Re: Preliminary Land Development Plan Approval
Beyond Meat, Inc.
Charlestown Township, Chester County

RE: Beyond Meat, Inc. Expansion (formerly Devault Foods)
Final Subdivision and Land Development Plan - Alternate Review #5
Fillippo Way & Devault Lane, Devault, PA

SUBJECT: **REVIEW COMMENTS - BEYOND MEAT**
ALTERNATE FINAL SUBDIVISION AND LAND DEVELOPMENT PLAN,
DATED REVISED SEPTEMBER 20, 2022; AND RESPONSE LETTER,
DATED SEPTEMBER 20, 2022

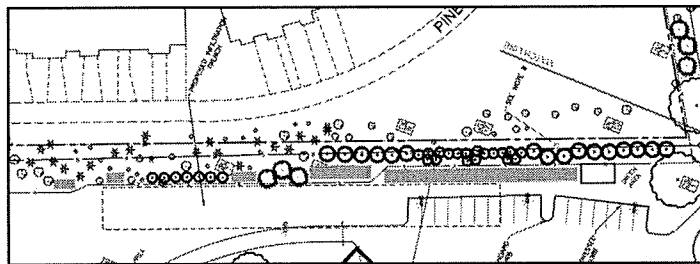
2. Buffer Recommendation #1 - Fill in Adjacent to Privacy Fence:

Consistent with discussions with Township Officials in 2020, there are areas adjacent to Spring Oak TND, on either side of the proposed Privacy Fence, where additional evergreen trees should be installed. These areas are shaded in green below.

The revised Plans indicate evergreen plantings in the areas indicated above. However, during the April 12, 2022 Charlestown Township Planning Commission Meeting, Mr. Westhafer requested consideration of adding more plantings to the berm. Please evaluate the possibility of adding plantings to the berm. Thank you.

The White Pine trees have been changed to Norway Spruce Trees. The number of evergreen trees has been increased from 16 to 80. However, it may be possible to add more plantings after the berm is reconstructed, and widened, and raised in height.
